TRANSMISSION SEMINAR 1991

TRANSMISSION SEMINAR

Technical Service Information

Figure 23

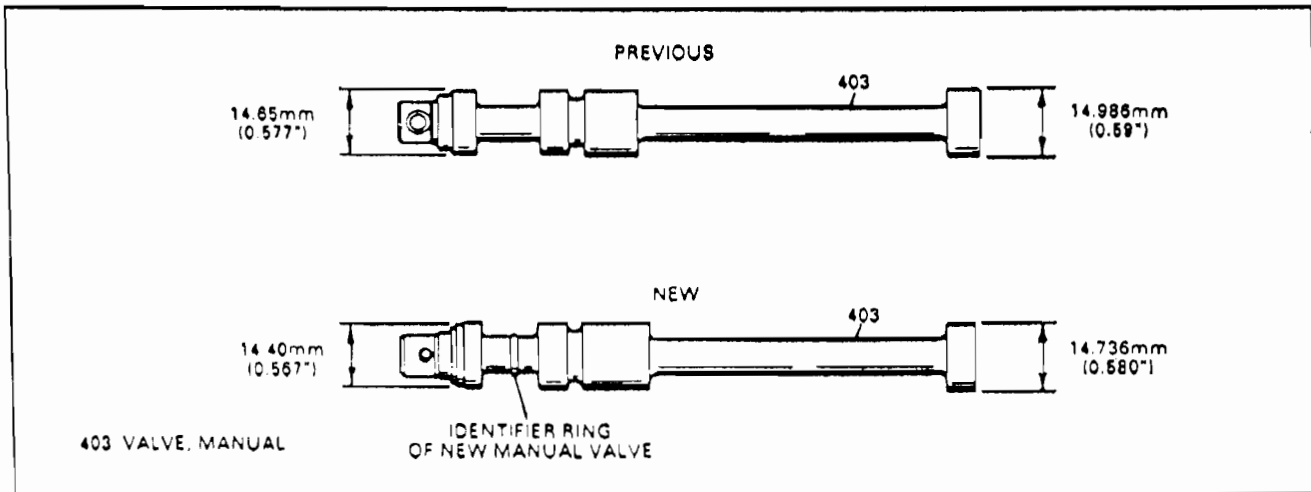
- (2) **NEW MANUAL VALVE** - Will have changes to the valve lands and reduced .010" in diameter for the new porting changes in channel plate. The previous and new manual valves are not interchangeable. The new manual valve can be identified by a ring between the first two lands as shown in Figure 23.

Figure 24

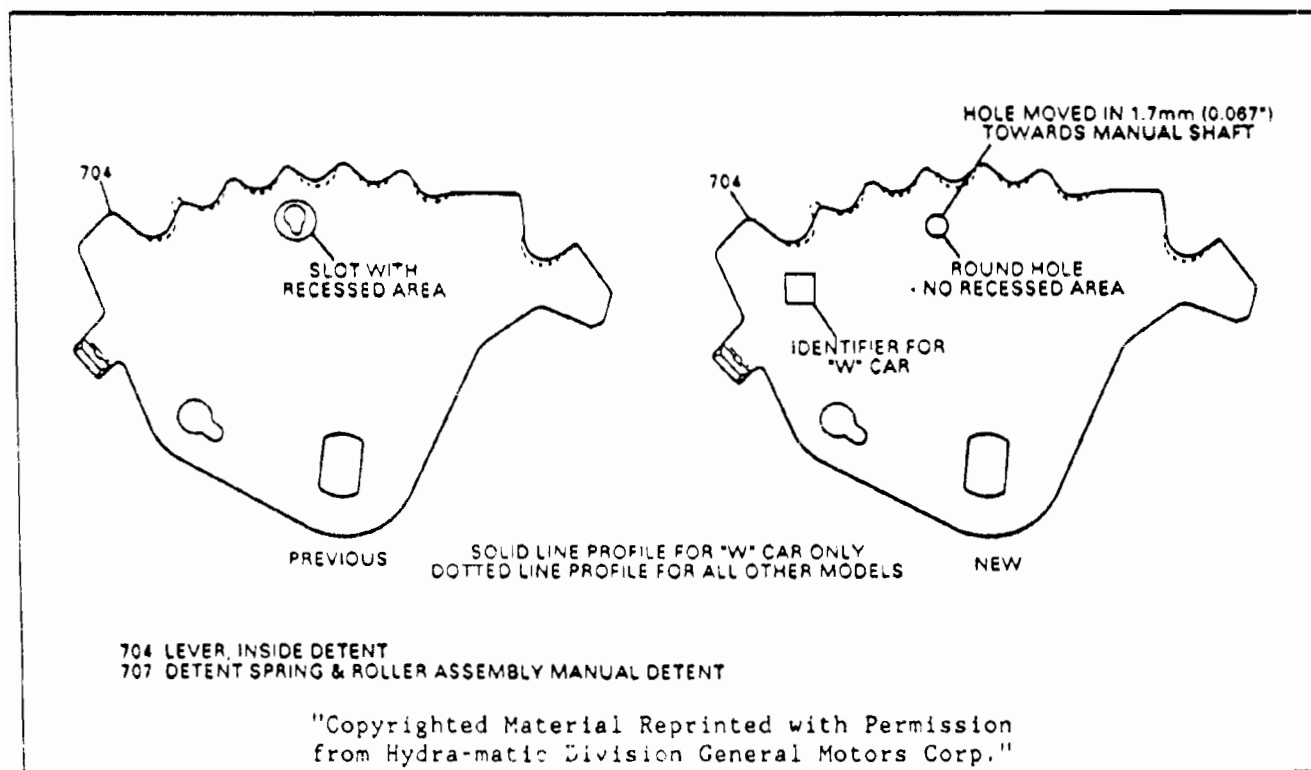
- (3) **NEW INSIDE DETENT LEVER** - Will have the manual link hole location changed to provide a different "Throw" of the manual valve, and the hole is now round instead of "Keyhole" shaped. Since the "W" car detent lever is different than all others, it will have square identification hole punched in it. The previous and new inside detent levers will not interchange. Refer to Figure 24 for I.D.

Figure 32
AUTOMATIC TRANSMISSION SERVICE GROUP

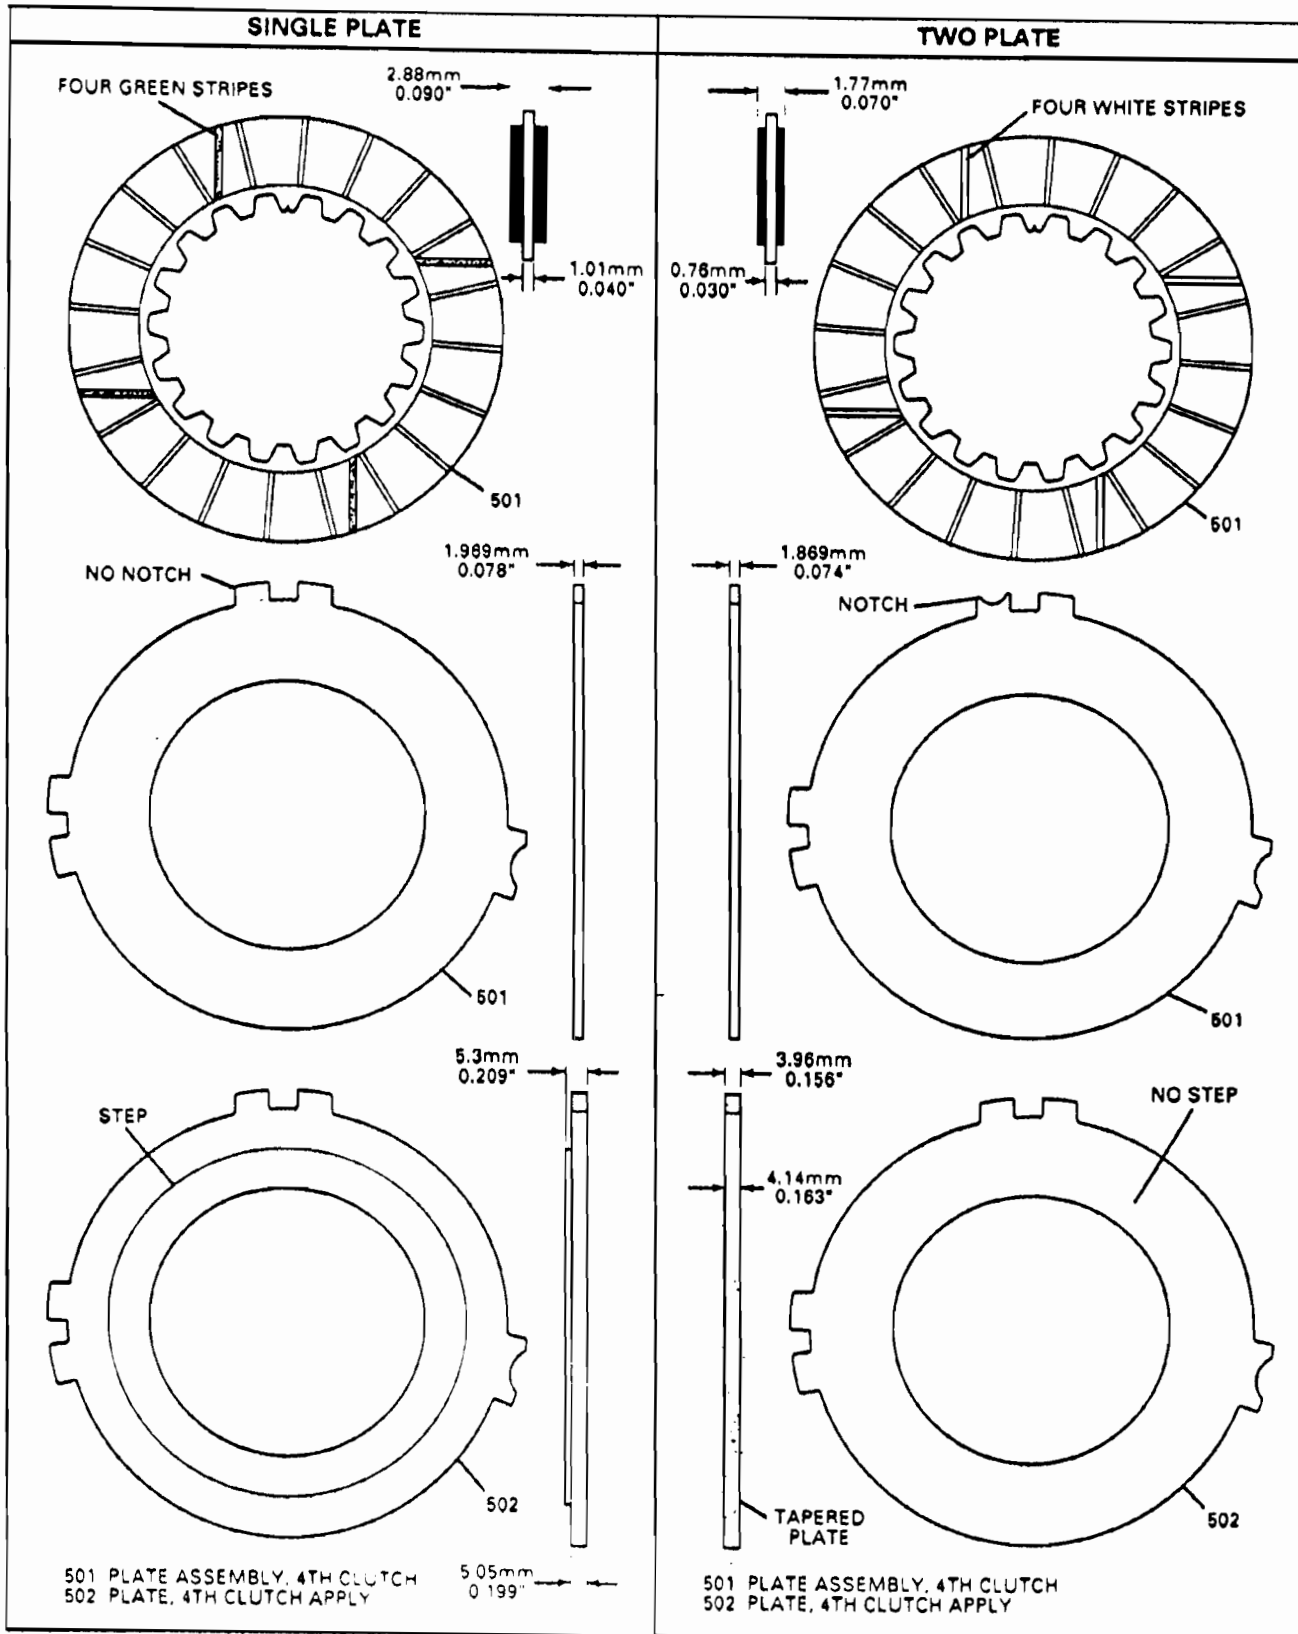
- (1) 4TH CLUTCH LINED PLATES - Were made thinner by .020" than the previous lined plate, and can be identified by the four WHITE stripes, while the single plate lined plate has four GREEN stripes (See Figure 32). The Single Plate 4th Clutch is .090" thick, and the new "Two Plate" 4th Clutch plates are .070" thick.
- (2) 4TH CLUTCH STEEL PLATES - Were made thinner by .004" than the previous plates, and can be identified by a "Notch" cut into one of the tabs (See Figure 32). The single plate 4th clutch steels are .078" thick, and the new "Two Plate" steels are .074" thick.
- (3) 4TH CLUTCH APPLY PLATE - Was machined thinner than the previous apply plate, and the step was removed. Refer to Figure 32.

Figure 33

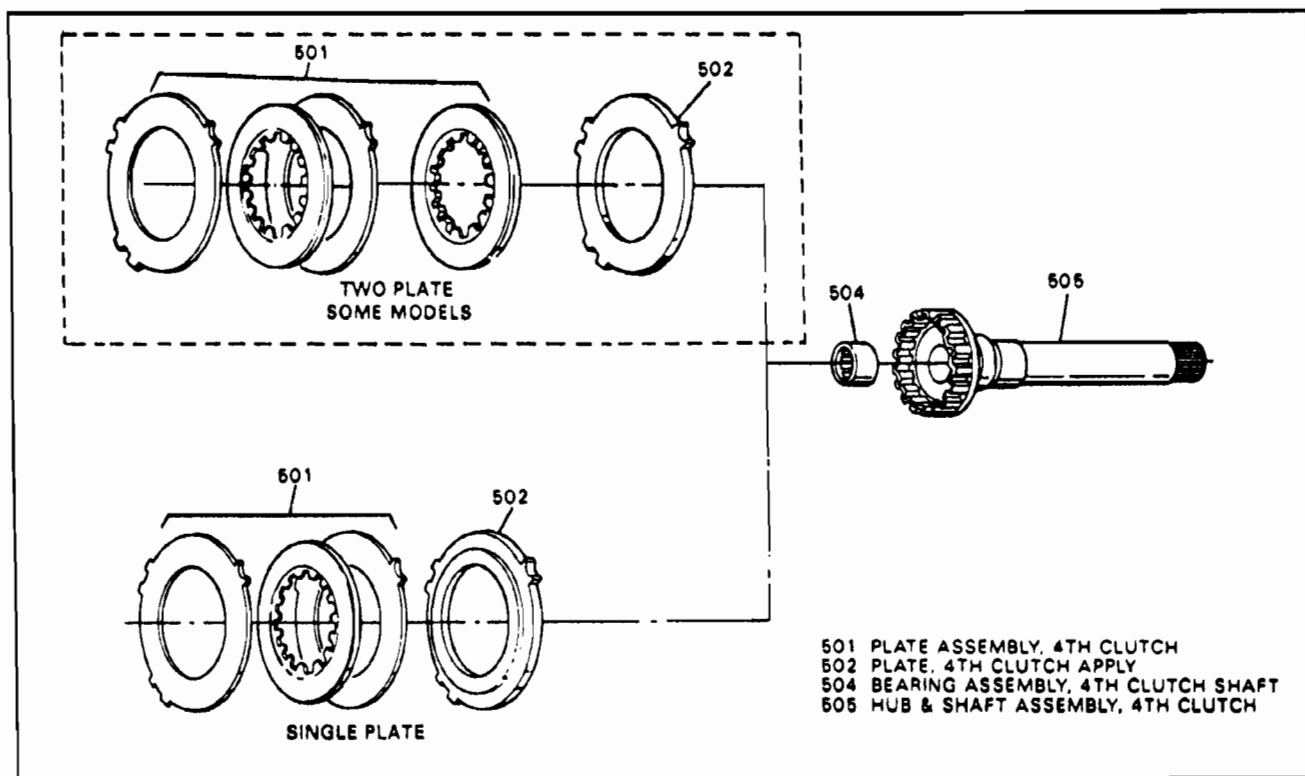
CHANGE: A new "Two Plate" 4th clutch assembly was used to replace the Single Plate 4th clutch assembly for SOME MODELS ONLY on the 1990 THM 440-T4 transaxles (See Figure 33).

Figure 35

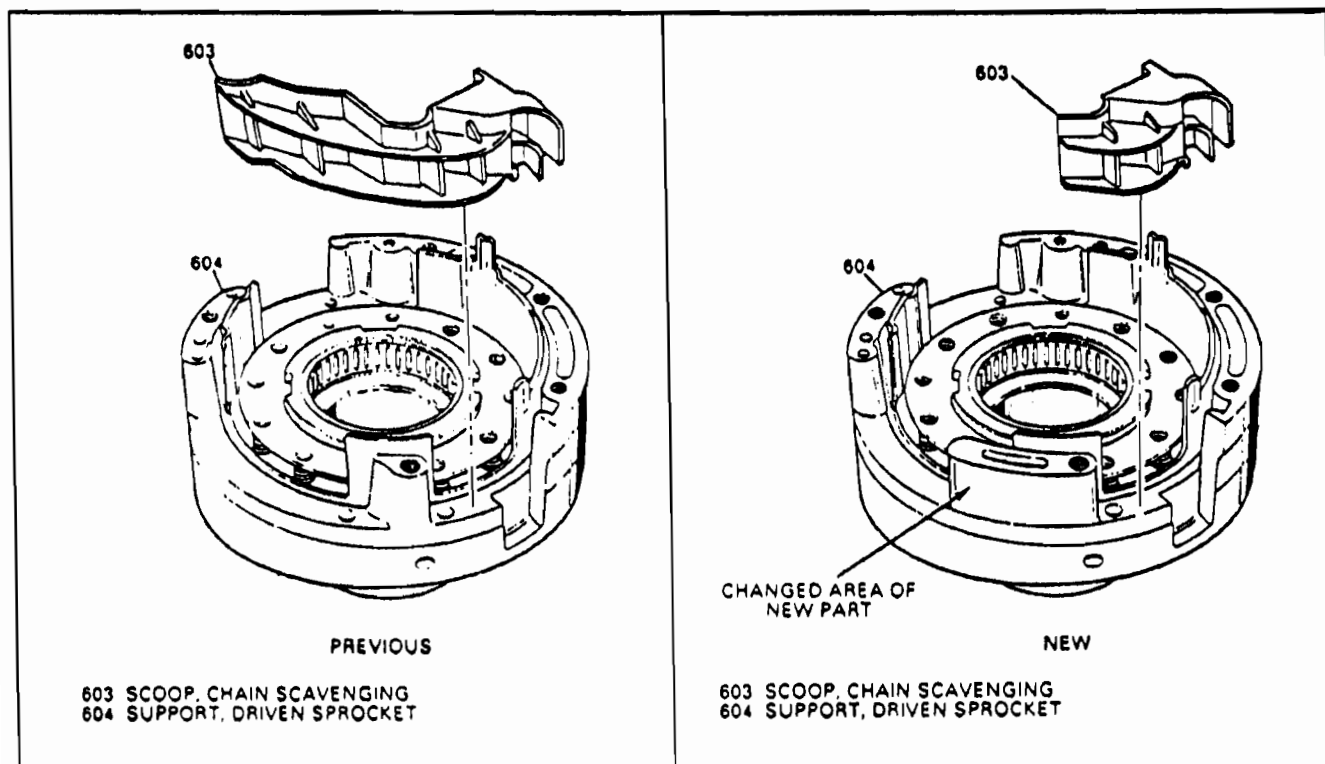
CHANGE: A new Driven Sprocket Support and Chain Scoop is now used in production on all 1990 vehicles equipped with a THM 440-T4 (4T60) transaxle. (See Figure 35).

- (1) **DRIVEN SPROCKET SUPPORT** - The new design sprocket support has an increased width of one leg on the support (See Figure 35). The wider leg on the new support will accommodate a new lube feed passage for the new THM F-31 (4T60-E) transaxle. Lube feed for the THM F-31 (4T60-E) will be thru the channel plate, instead of the pipe from the accumulator cover as on the THM 440-T4 (4T60) (See Figure 36).
- (2) **CHAIN SCOOP** - The new sprocket support requires the chainscoop, both black and white, to be about 1/3 the length of the previous chain scoop. (See Figure 35).

The new driven sprocket support will service all past models, but the new length (Short) chain scoop must be used with it. The previous (Long) chain scoop will not fit, but can be cut to fit the new support. Lay the previous chain scoop on the actual size drawing in Figure 37 and cut straight down, as indicated, with a hack saw. Smooth off the rough cut edge with sandpaper. The new length (Short) chain scoop must be used ONLY with the new design driven sprocket support.

Figure 38

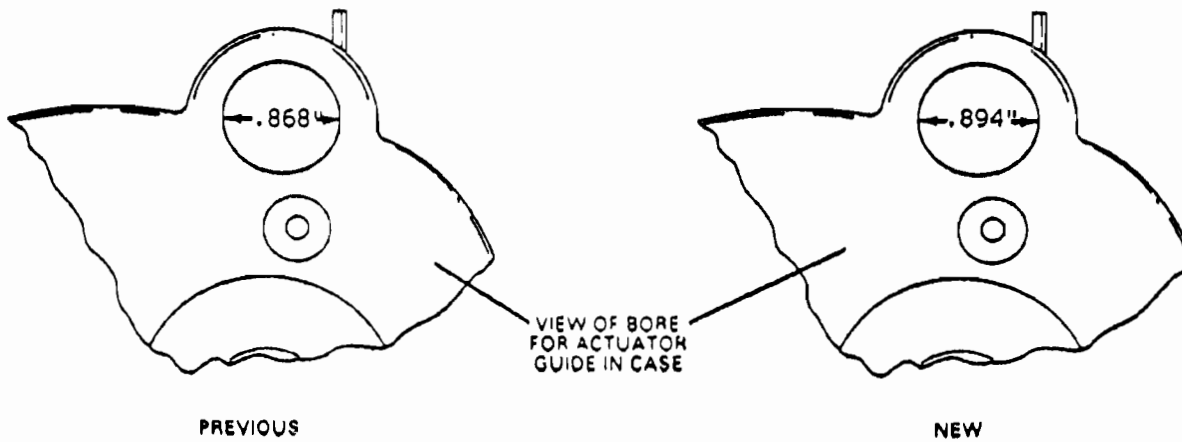
- (1) TRANSAXLE CASE - Bore diameter for the actuator guide has been increased by .026", to accomodate the new actuator guide (See Figure 38).
- (2) ACTUATOR GUIDE - Outside diameter has been increased by .026" for the increased diameter of the "Bullet" on the parking rod. The plunger assembly and spring have been eliminated. The slot in the actuator guide has also been eliminated (See Figure 39).
- (3) ACTUATOR GUIDE "O" RING - The "O" ring is now a larger diameter to seal the larger diameter actuator guide (See Figure 39).
- (4) PARKING ACTUATOR ROD - The "Bullet" on the park rod is now .070" larger in diameter, and the length increased by .543" (See Figure 40).
- (5) PARKING PAWL - The parking pawl lock-out pin has been eliminated, and the dimension (Width) of the parking pawl was reduced by .039" (See Figure 41).

Figure 42

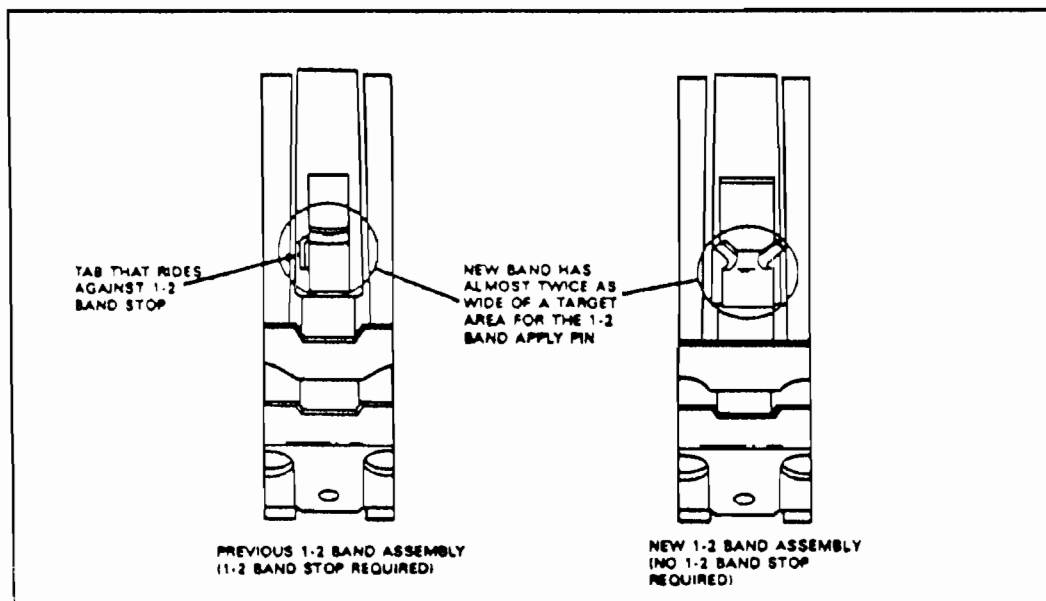
- (1) 1-2 BAND ASSEMBLY - The target area on the new 1-2 band, where the band apply pin engages, has been made wider and has "Wings" added to prevent the pin from ever missing the "Target" area (See Figure 42).
- (2) 1-2 BAND STOP ASSEMBLY - The 1-2 Band Stop has been eliminated as it is no longer needed (See Figure 43).

Figure 44

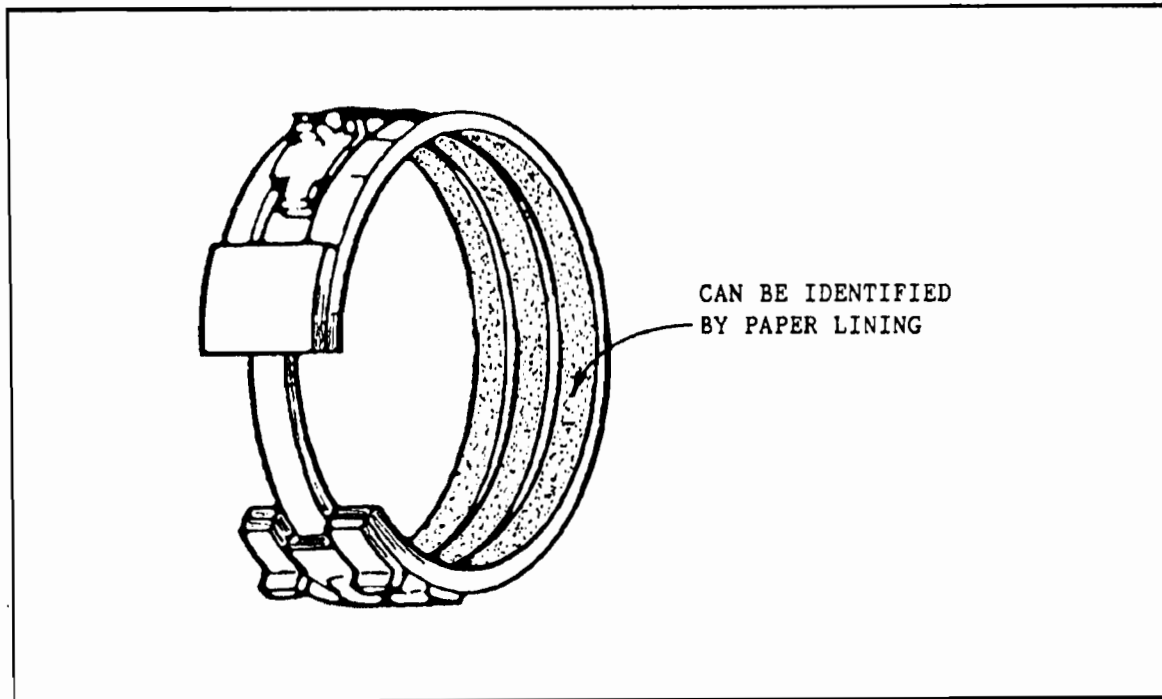
- (1) REVERSE BAND ASSEMBLY - The lining on the reverse band has once again been changed, and can be identified by the "Paper" lining on the band itself (See Figure 44).

Figure 45

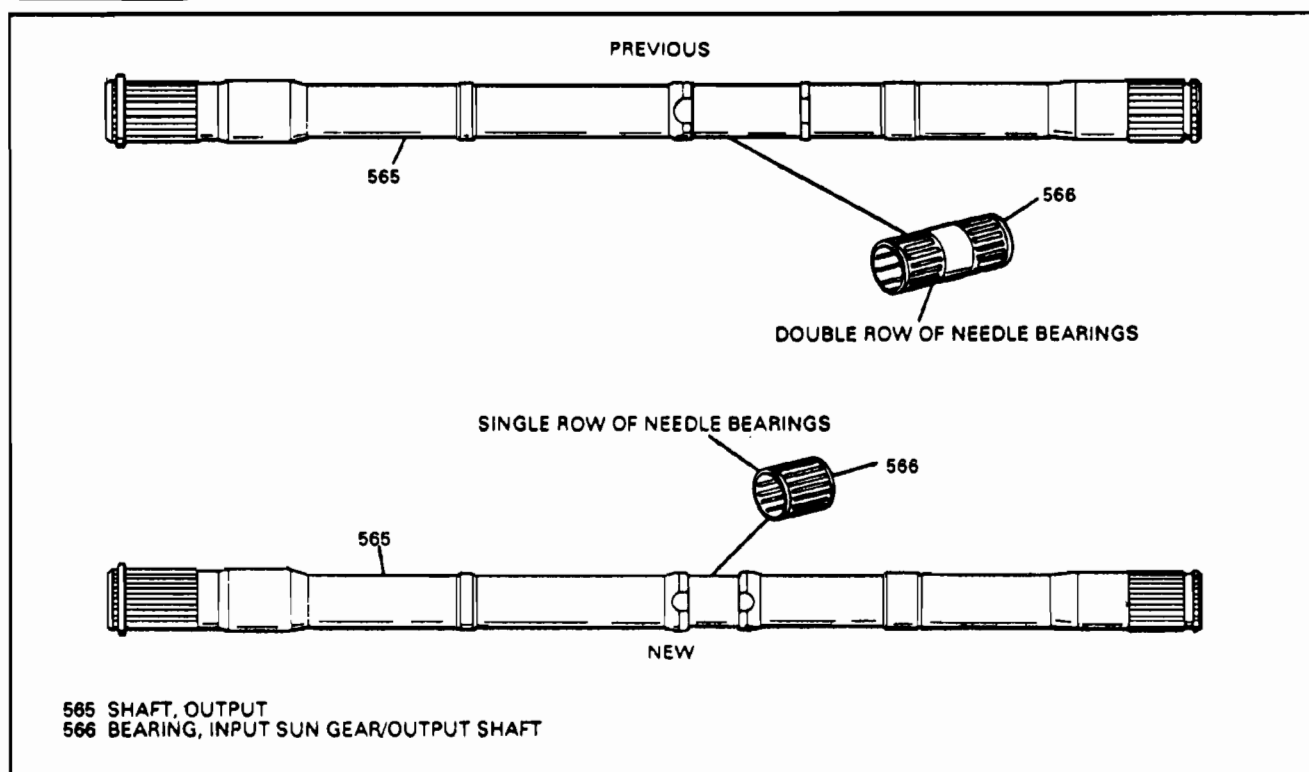
- (1) **OUTPUT SHAFT/BEARING** - The new bearing has a single row of needle bearings instead of a double row, and the output shaft is machined different to accommodate the new bearing (See Figure 45). This change will improve lube oil flow to the 3rd roller clutch and input sprag.
- (2) **3RD ROLLER CLUTCH ASSEMBLY** - The new 3rd roller clutch outer race has four (4) less lube holes than previous models. The four lube holes are in line with the very end of the rollers (See Figure 46). Elimination of these holes helps keep the rollers from "Skewing" (Running at an Angle), thus generating less heat.
